**MASTER DEVELOPMENT DRAINAGE PLAN
AND FINAL DRAINAGE REPORT FOR
WATERBURY FILINGS NO. 1 & 2
EL PASO COUNTY, COLORADO**

DECEMBER 2020

Add text:
PCD Filing No.:
PUDSP-21-005

Project: WATERBURY FILING 1
 Basin ID: Design Point 30- Triple 36" RCP Culverts
 Status:

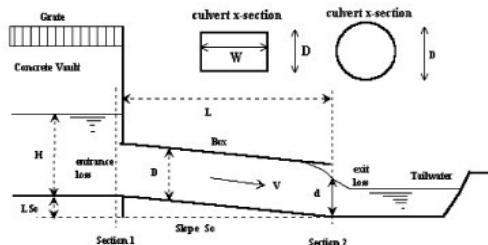
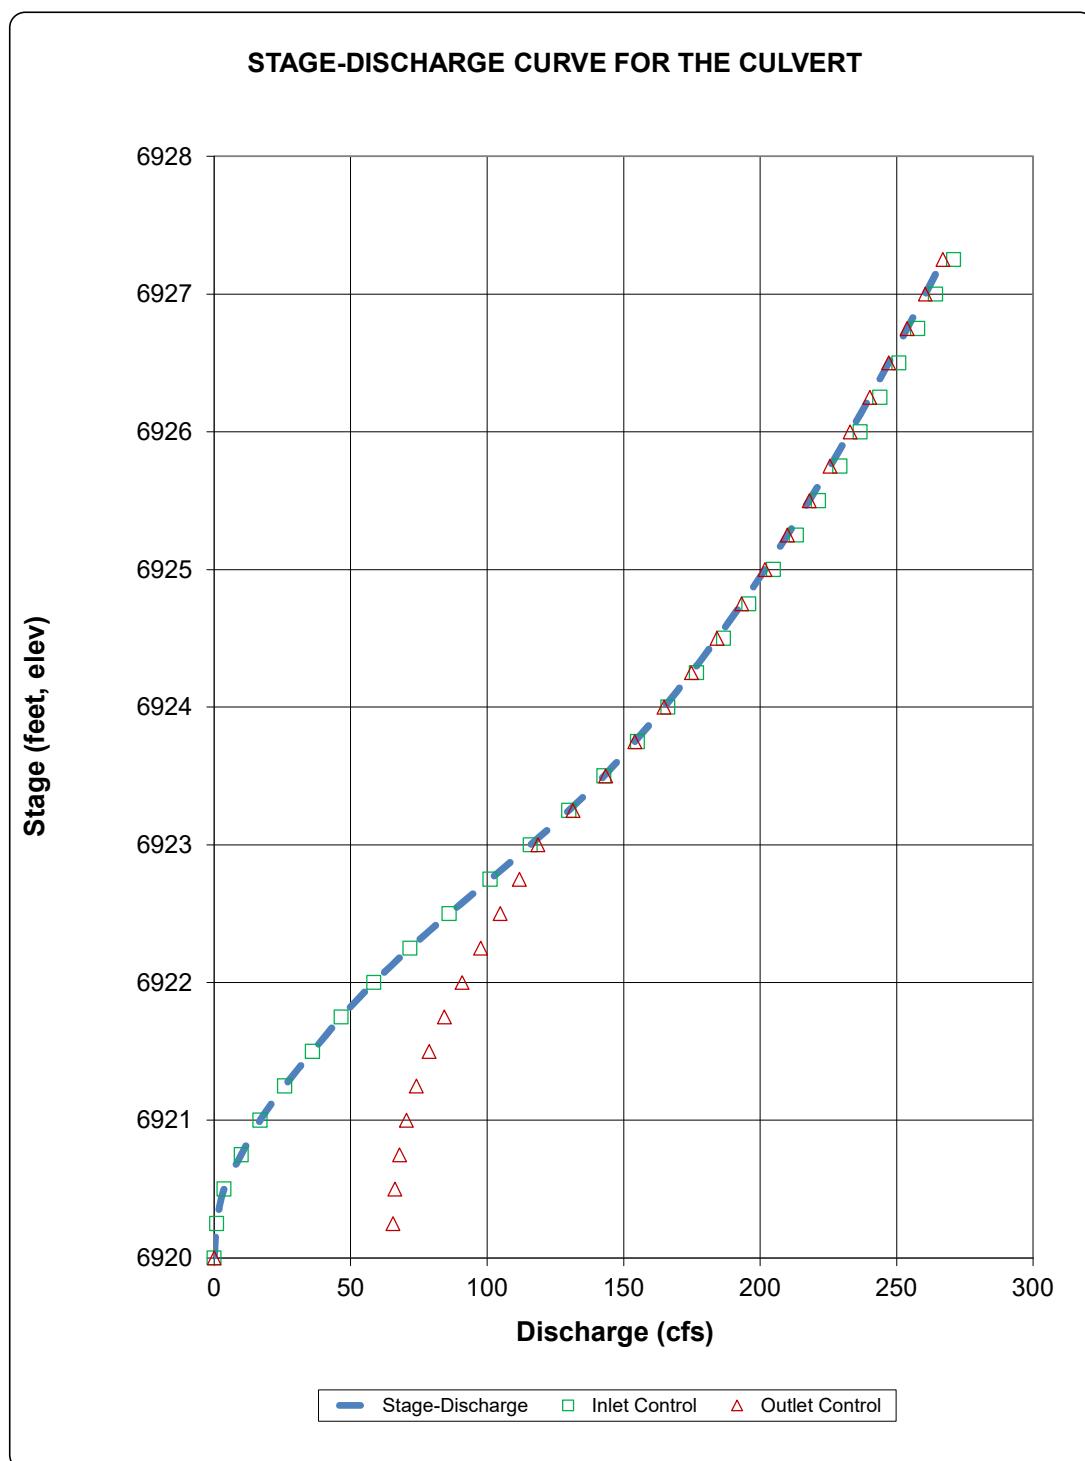
Also provide for DP11

DETENTION BASIN OUTLET STRUCTURE DESIGN

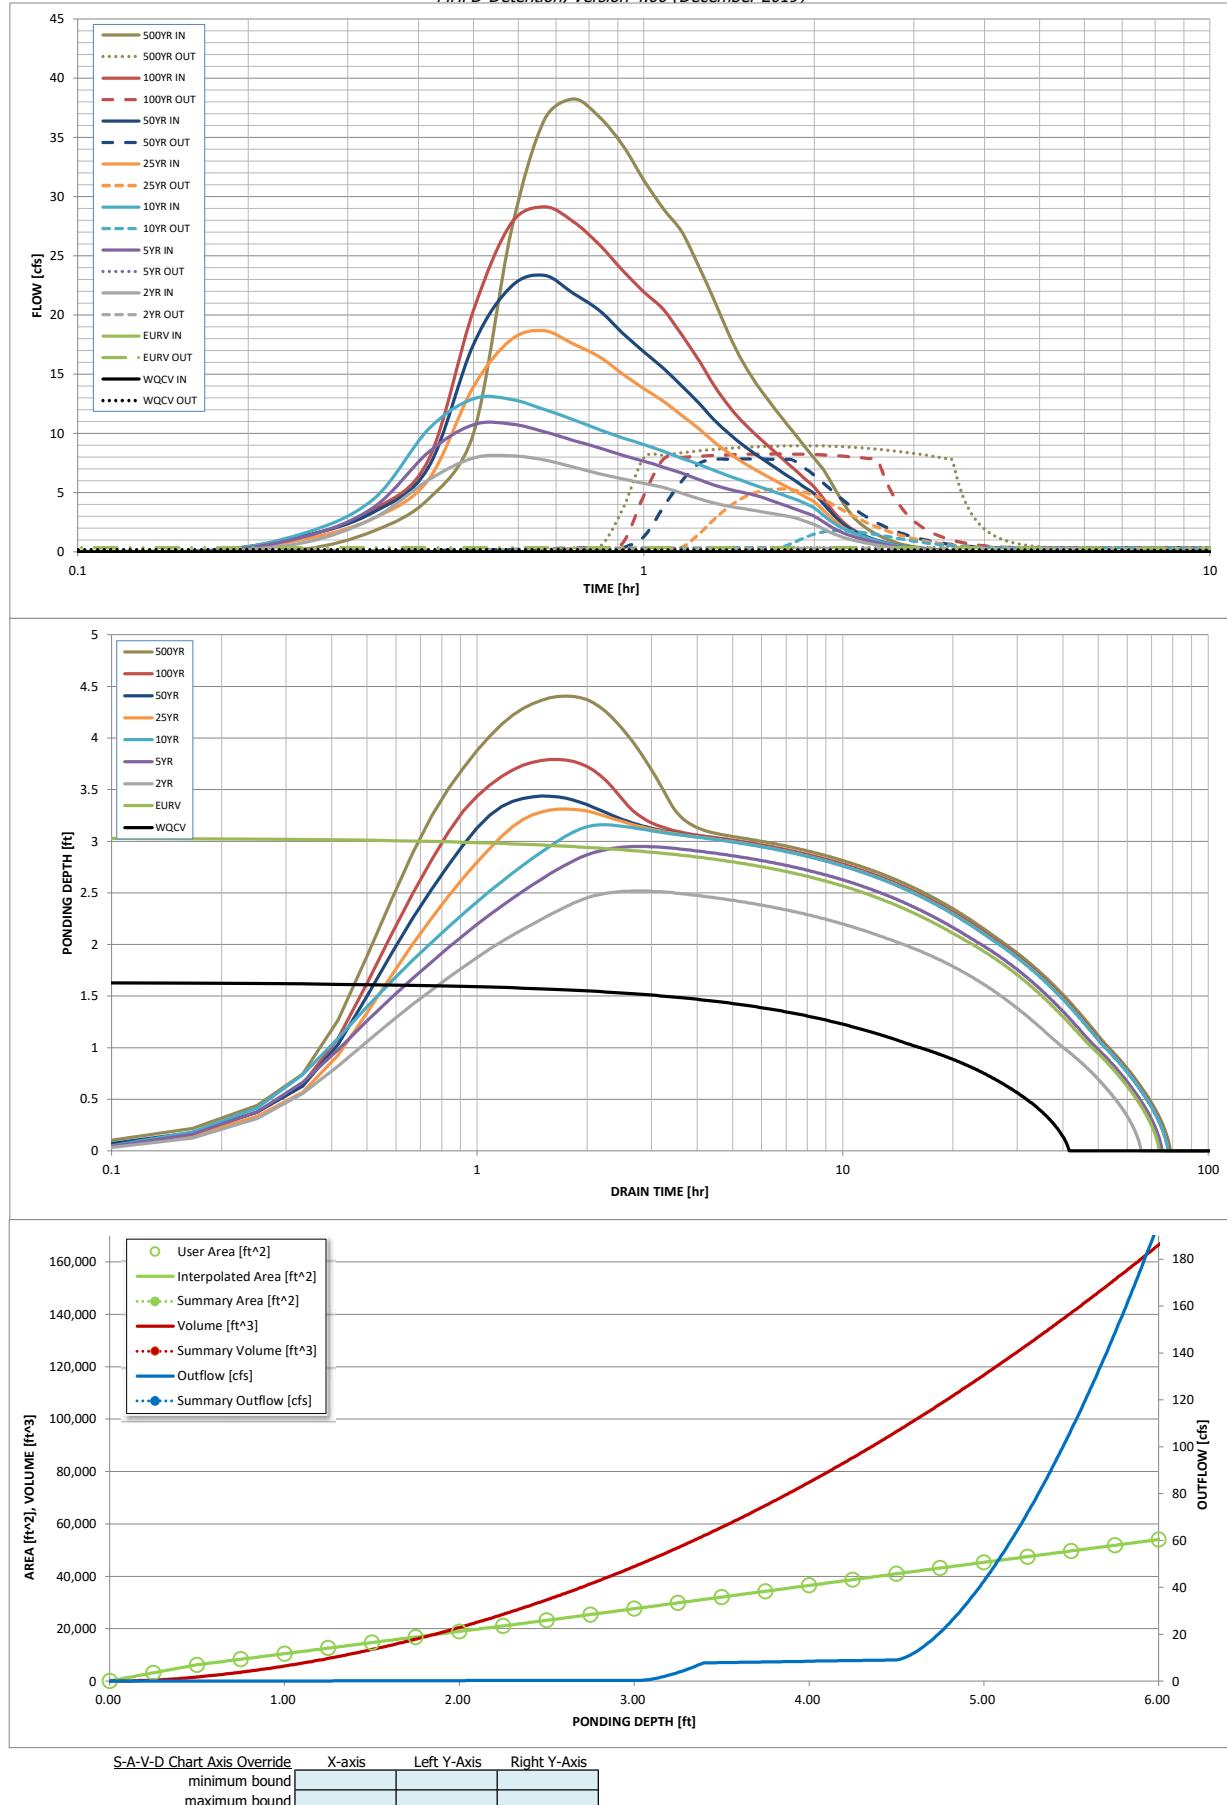
This should be <1

WATERBURY FILING 1 & 2
PROPOSED MDDP DRAINAGE MAP
OFFSITE MAP

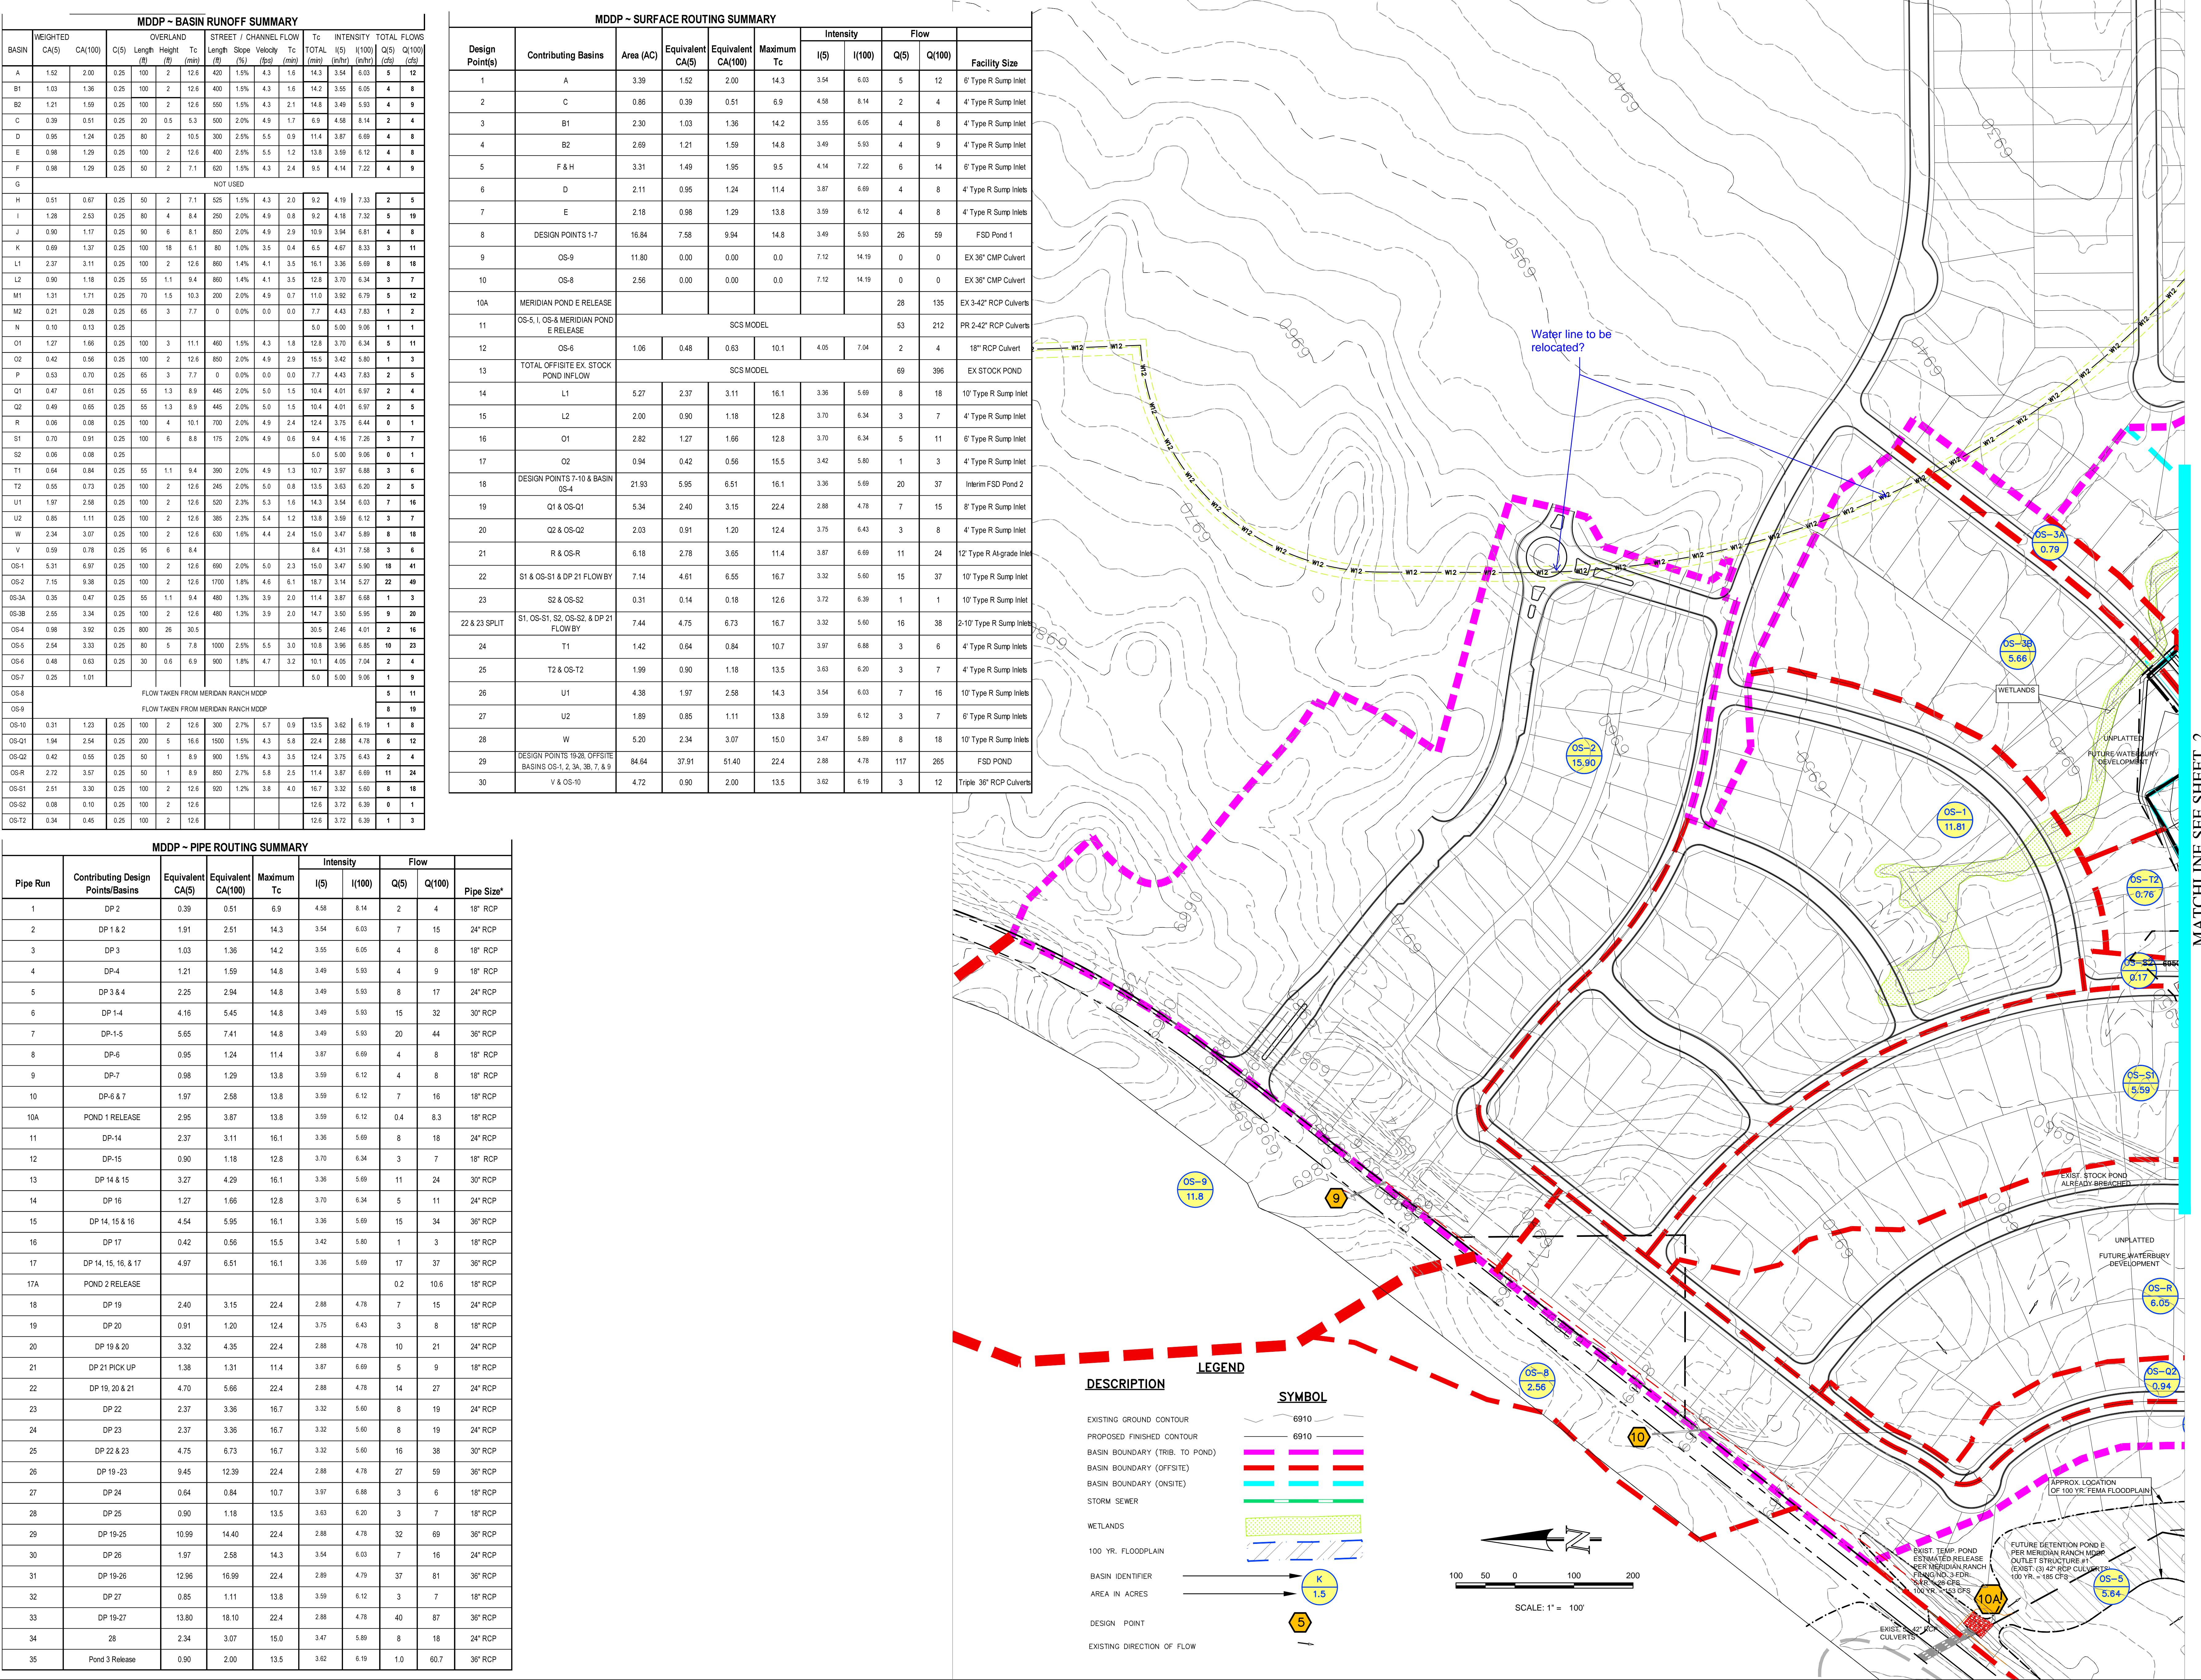
These do not match what is shown on the drainage map on Page 301. Basins trib to Pond 1 appear to be A, B1, B2, part of C, D, E, F, H, K

These do not match what is shown on the drainage map on Page 301. Revise.

These do not match what is shown on the drainage map on Page 301. Revise. Basin D and E are actually trib to Pond 1 for example.

These do not match what is shown on the drainage map on Page 301. Revise.

Provide existing conditions drainage plan.

Provide pre-development grading drainage plan
